**PLANNING COMMISSION SITE PLAN  
WAIVER REQUEST ONLY**

**CASE NUMBER:** SP-2010-0198C      **PLANNING COMMISSION  
HEARING DATE:** November 9, 2010

**PROJECT NAME:** Town Lake YMCA

# Response to WPAB's conditions - Project Architect Keith Hickman

Figure 1 - 8:00 am Parking Lot Shading

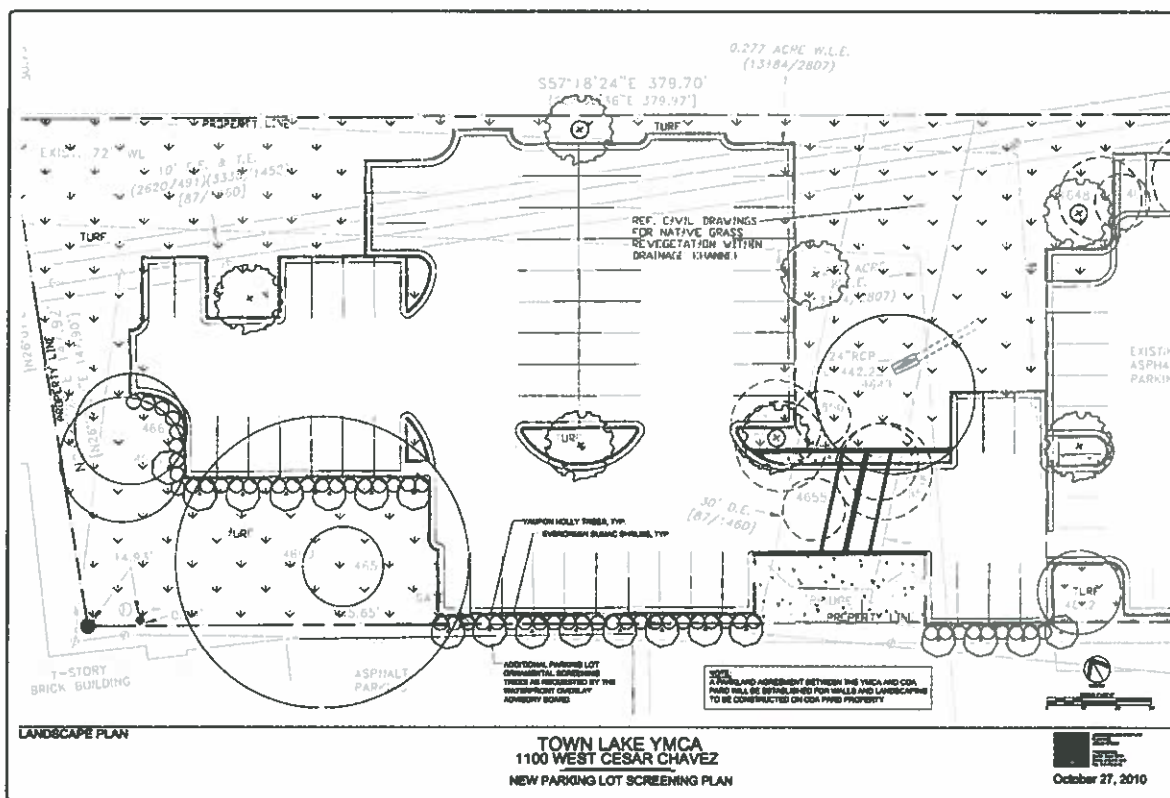
- One of the concerns voiced within the comments we received from the Planning Commission is that the "While tree mitigation is adequately provided the parking lot is left barren and relatively free of valuable tree shading." Daniel Woodroffe Waterfront Planning Advisory Board
  - Following is a shading study showing the amount of shading on the new parking area at different times of day. We choose November 2, 2010 as the time of the year.

As you can see from these studies, the Parking Area is not left barren, but receives shading throughout the day. We have retained many of the existing trees as well as planted new trees. Seven new trees have been added to the new Parking Area to replace the six trees removed from the existing drainage ditch.
